**COMMENT RESPONSES/REVISIONS TO THE DRAFT IMPLEMENTATION PLAN FOR  
ABOVE-GRADE DECONTAMINATION AND DISMANTLEMENT OF THE SEWAGE  
TREATMENT PLANT COMPLEX**

**SEWAGE TREATMENT PLANT COMPLEX  
IMPLEMENTATION PLAN  
FOR ABOVE-GRADE  
DECONTAMINATION AND DISMANTLEMENT**

**COMMENT RESPONSE PACKAGE**

**FERNALD ENVIRONMENTAL MANAGEMENT PROJECT  
FERNALD, OHIO**

FIGURE 1-1 Sewage Treatment Plant Complex Project Area

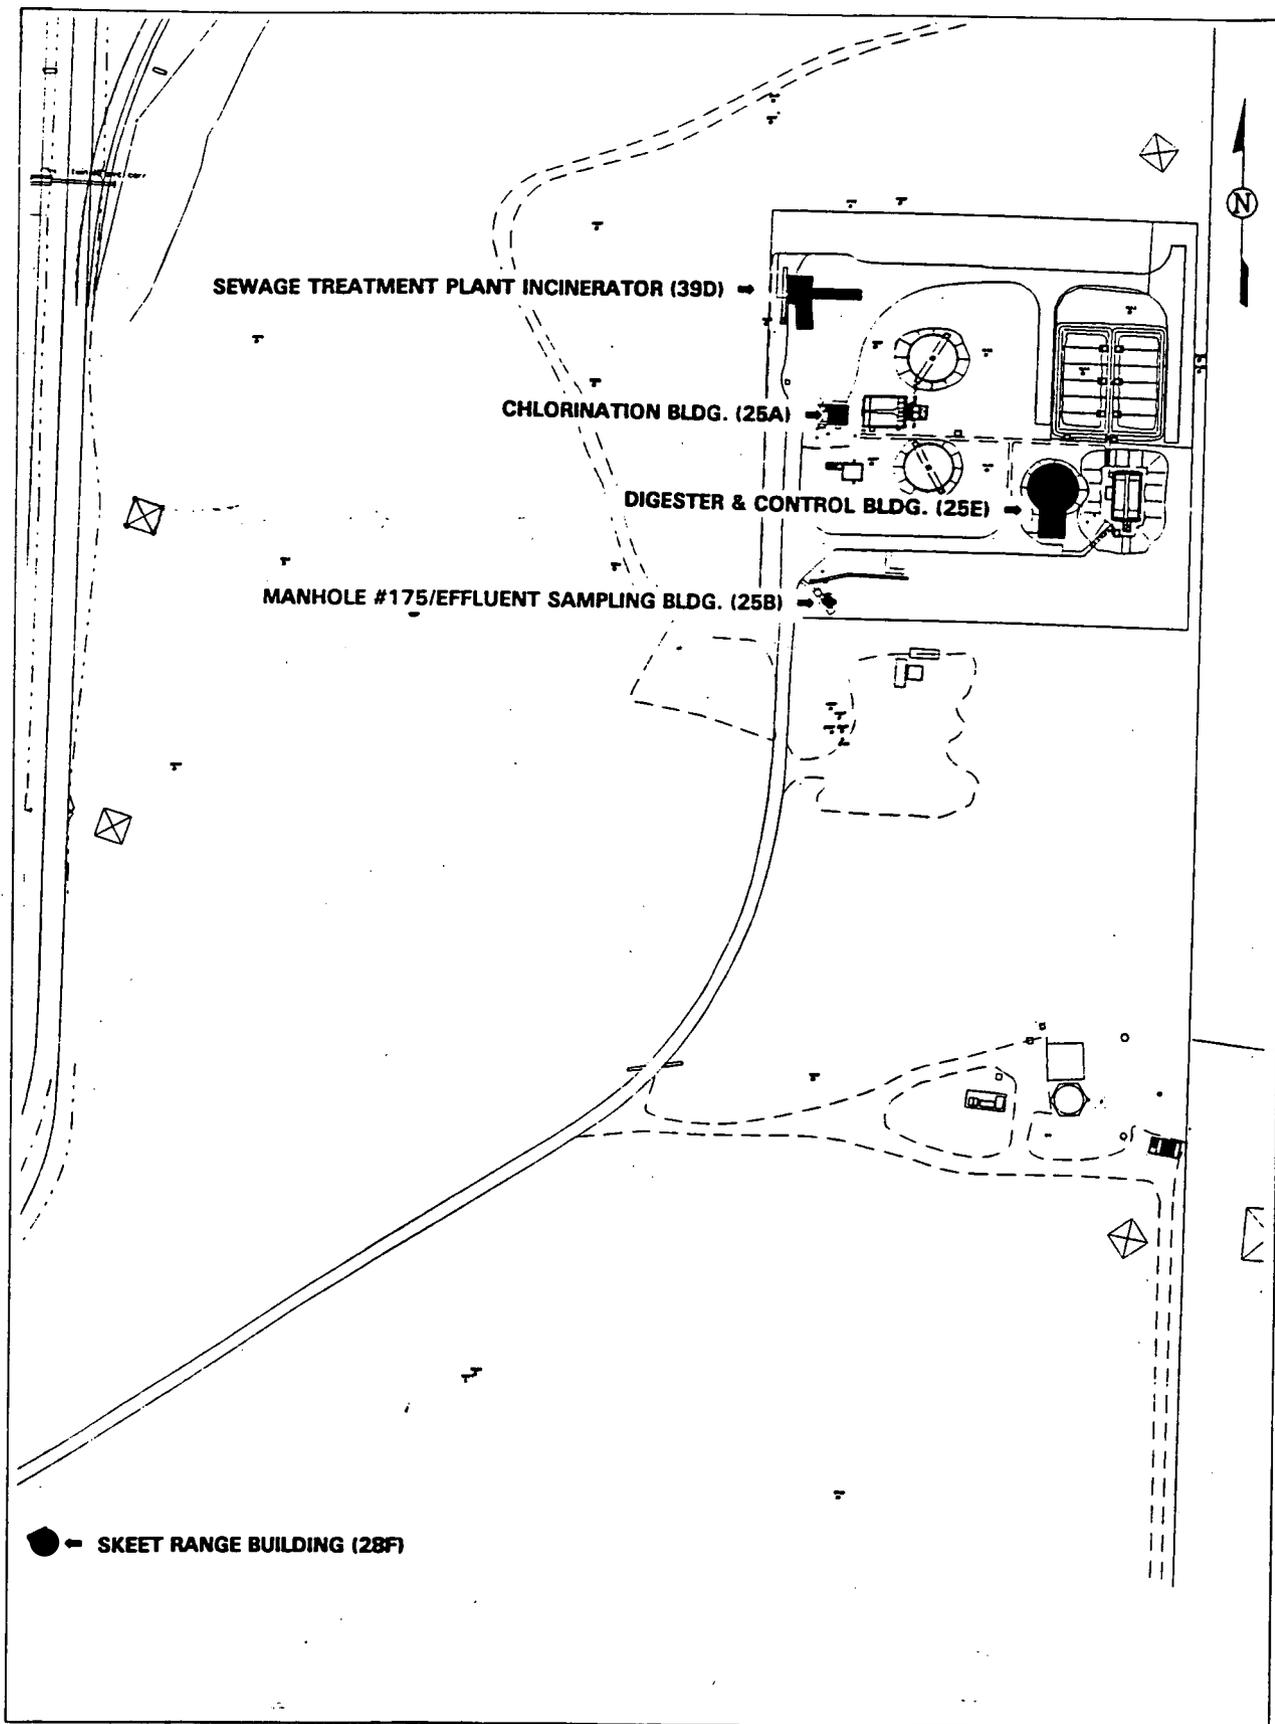
Significant DOE Enhancements to Draft (Pg./Line Nos.)	Basis for Enhancement
1. Figure 1-1, Tables 2-2, 2-3, 2-4, Sections 2.1, 2.3.5, 3.6, and Figures D-11 and E-9 (removed)	Removed the Cincinnati Gas & Electric (CG&E) High Tension Electrical Tower from the project scope. This decision was made due to unsettled negotiations with the regional power utility, CG&E, regarding safe work plans on removal of transmission line, which must precede the tower removal. CG&E indicated that it would not be able to remove the cable prior to the STP D&D project NTP date. This structure will now be dismantled under the scope of the Miscellaneous Small Structures D&D Project and be reflected in the next version of the implementation plan for that project.
